2015 Configuration with RDI Leave Addition Comparison with Rennie's Suggestions

Introduction to VIA Report

FL A87597 will lay on a landform previously impacted by large, angular cutovers. An initial plan of rehabilitation of the cutovers was prepared in 2013 and 2014 by BCTS. RDI prepared a VIA based on that plan. The plan had the objective to reduce the amount of forest between the cutovers at an early enough stage so that old and new cutovers would merge to reduce the horizontal line effect, and to allow re-growth together into a single-aged large pattern of openings.

**1730.3- 2015 Configuration with RDI Leave Addition plus Rennie Units 3,7 and 8
Percent Alteration Calculation within Partly Screened Landform Portion of VSU 1143: 13.8%**

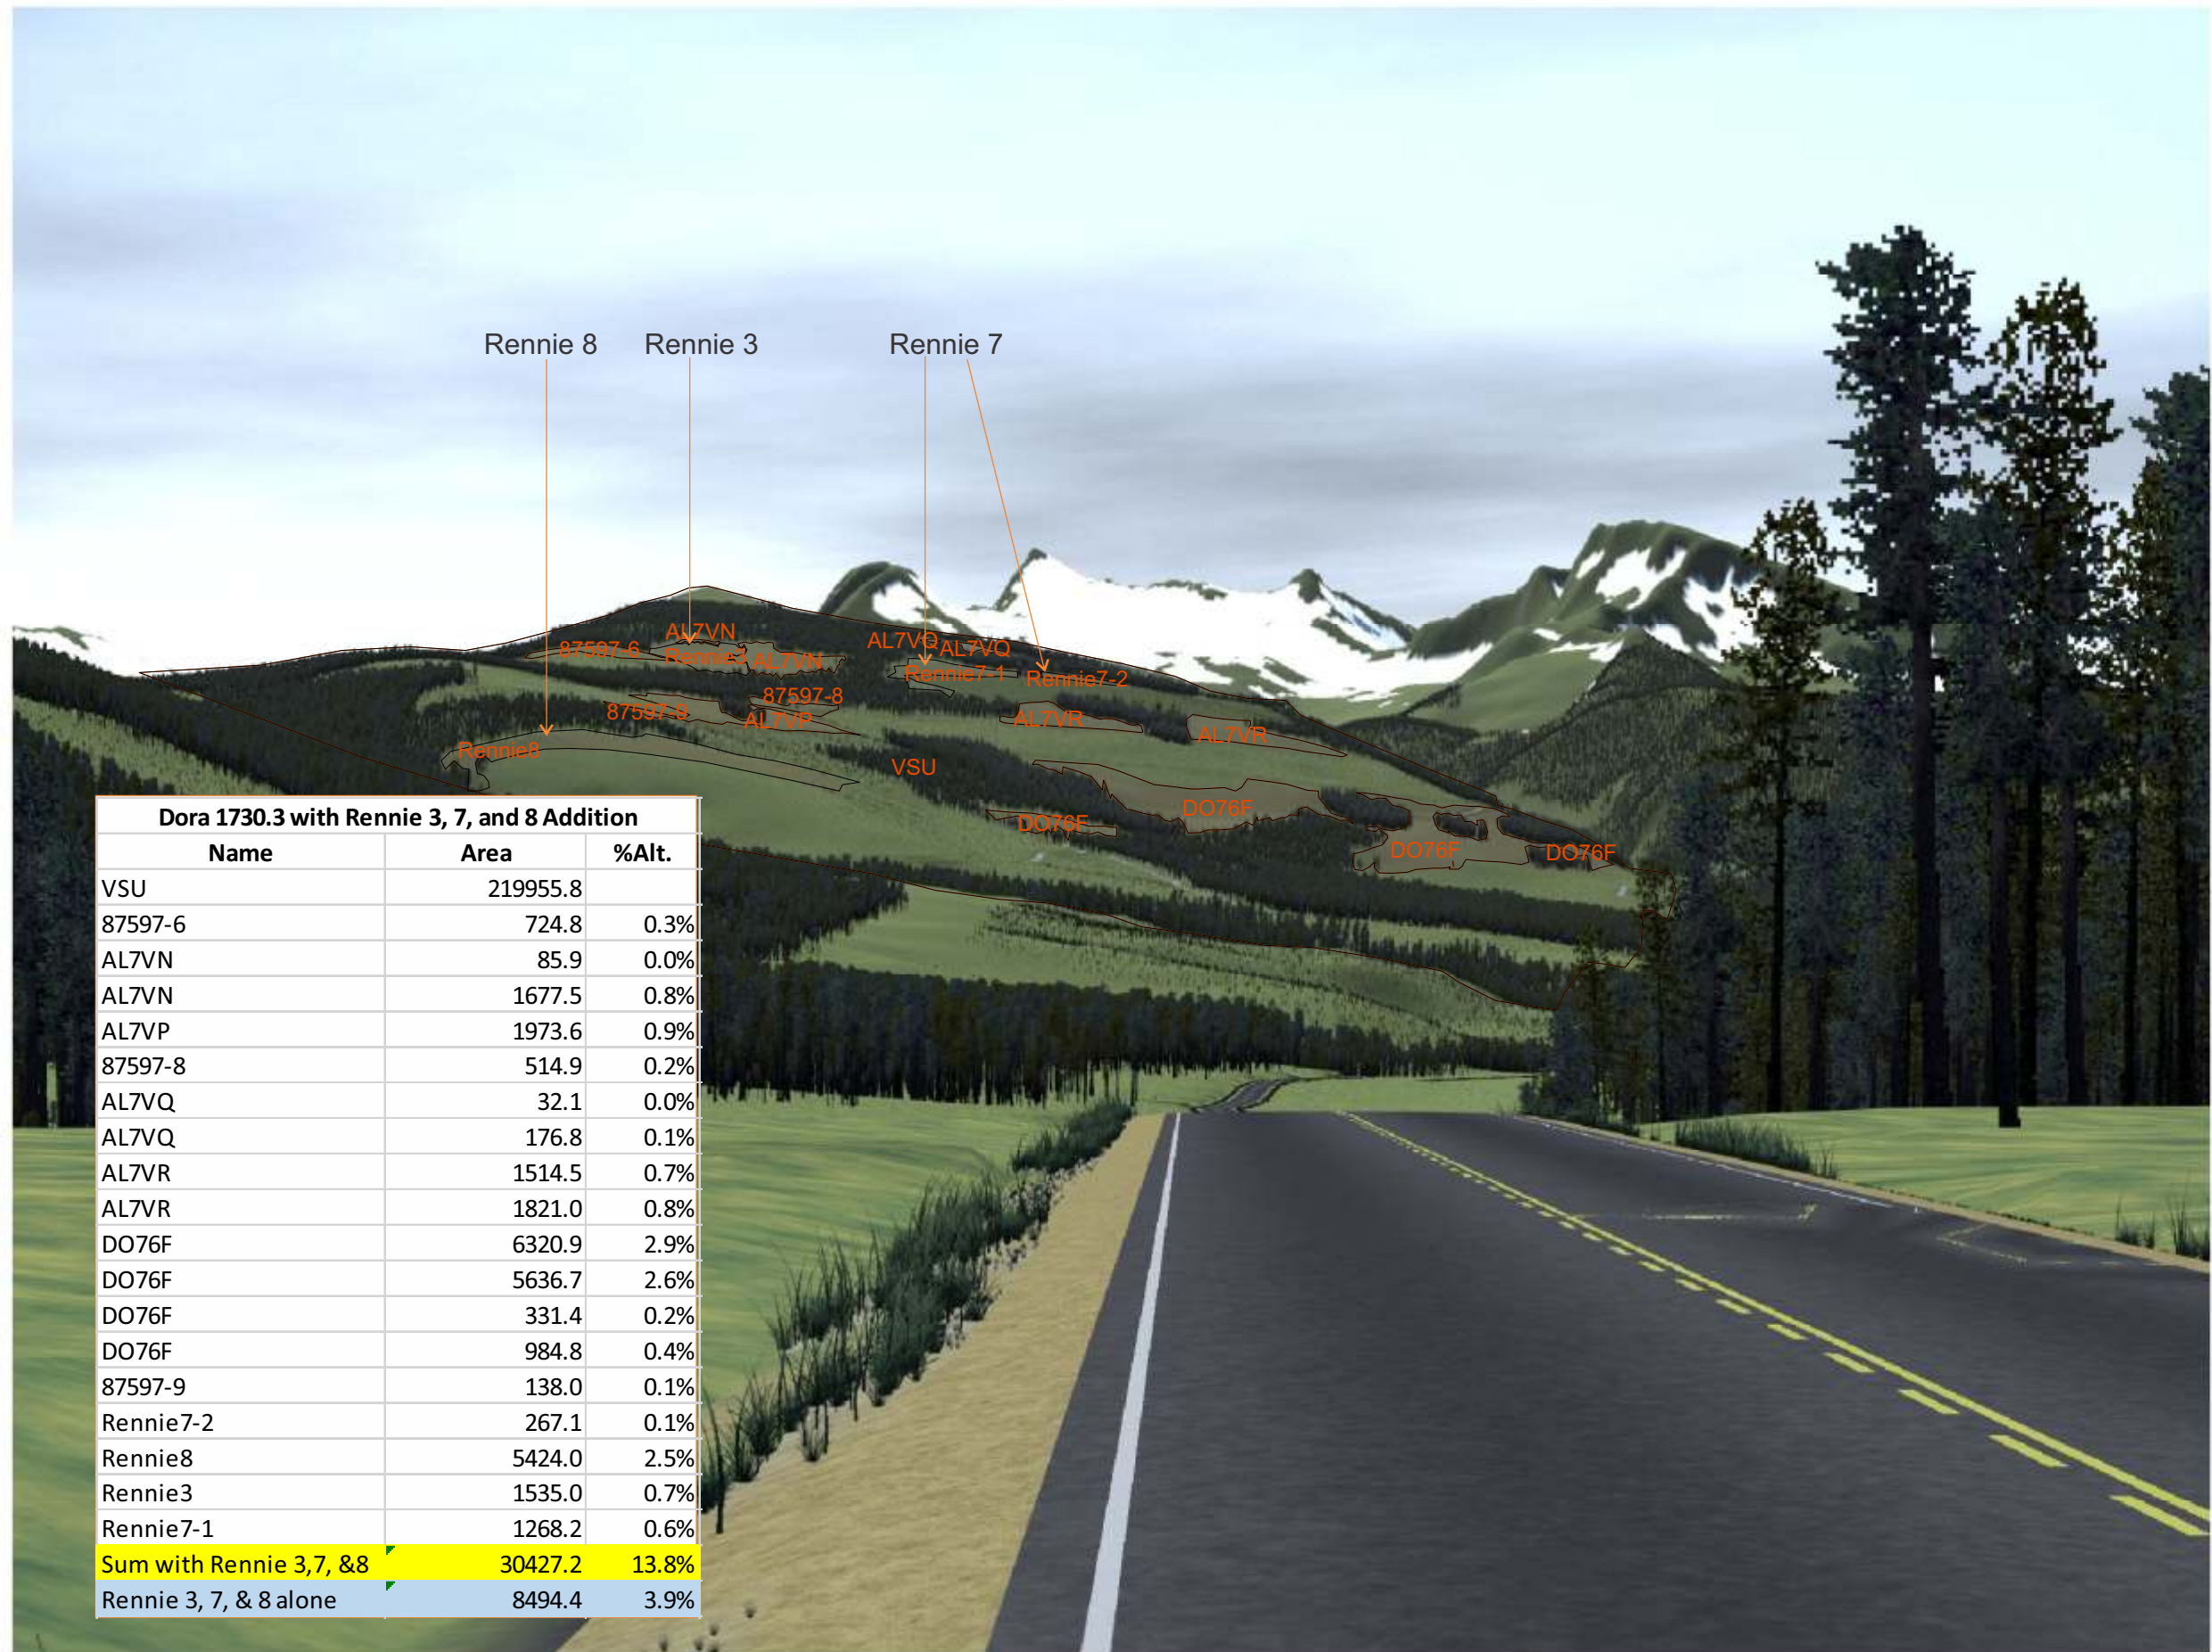
Of the 10 areas suggested by Rennie for additional cut or leave, all but 3 areas were incorporated by BCTS. Three areas for additional cut recommended by Rennie, units 3, 7, and 8, were not included in the final BCTS plan, nor were they recommended by RDI for inclusion in the plan as they would incur additional percent alteration. For example, the three additional cuts would create an additional 3.9% alteration from viewpoint 1730.3, as compared to 10% in the current plan.

Some angularity, namely in the northeast corner of cutover area #4 may still be adjusted with some more limited harvesting in Rennie7 if operationally appropriate.. The Rennie suggested areas are presented on the second key map at the front of the VIA document, and simulated on the final page.
